Subject: Notification as required by 10CFR Part 21

As required by 10CFR Part 21 we are advising you of a potential safety related problem with our 2 1/2", 3" and 4" forged swing check valves.

The problem is that the swing check valve may jam in the open position because of an accumulation of tolerances in the cage unit of the swing check assembly (sketch attached). Design changes have been made to eliminate this in future production of these valves and spare parts.

## *DCPP INSPECTION RESULTS FOR 3" AND 4" VELAN SWING CHECK VALVES*

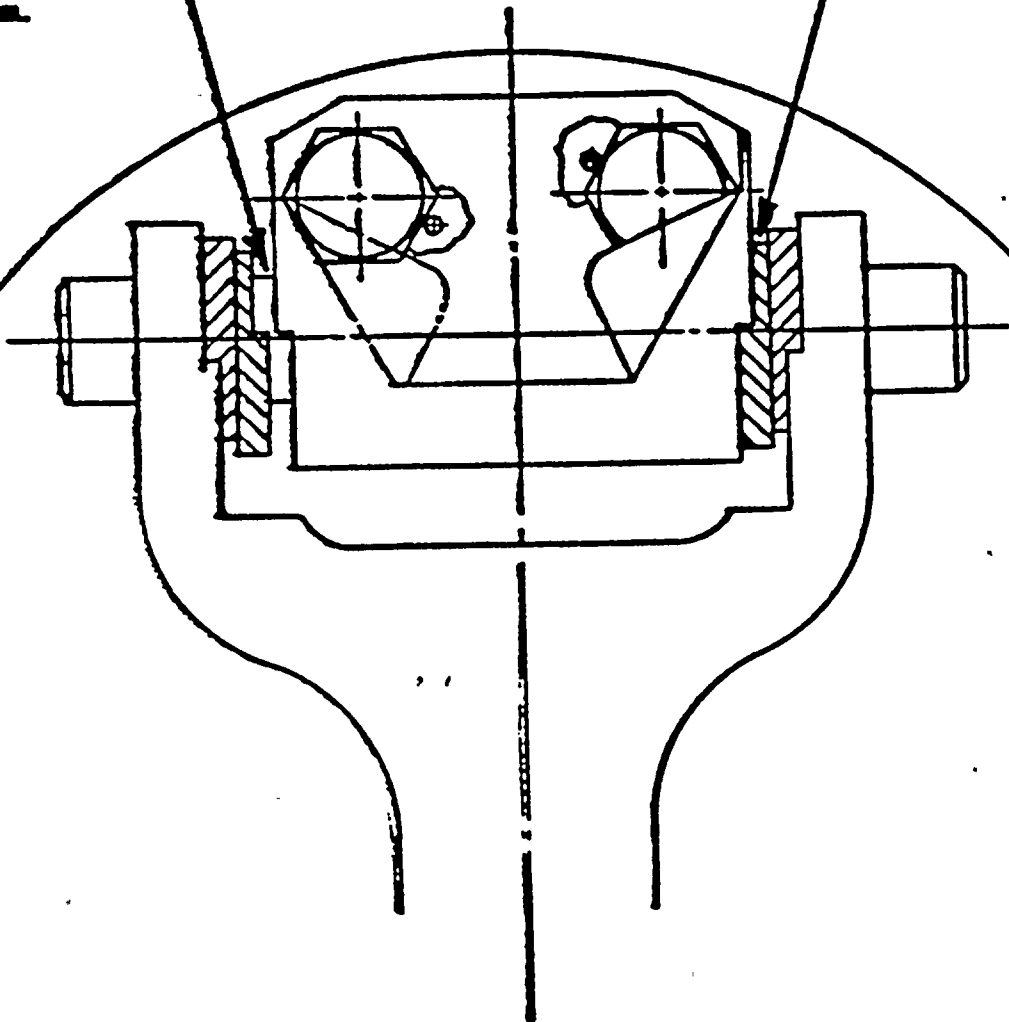
**Clearance**  
**May cause**  
**problem.**

**Engagement**  
**Satisfactory**
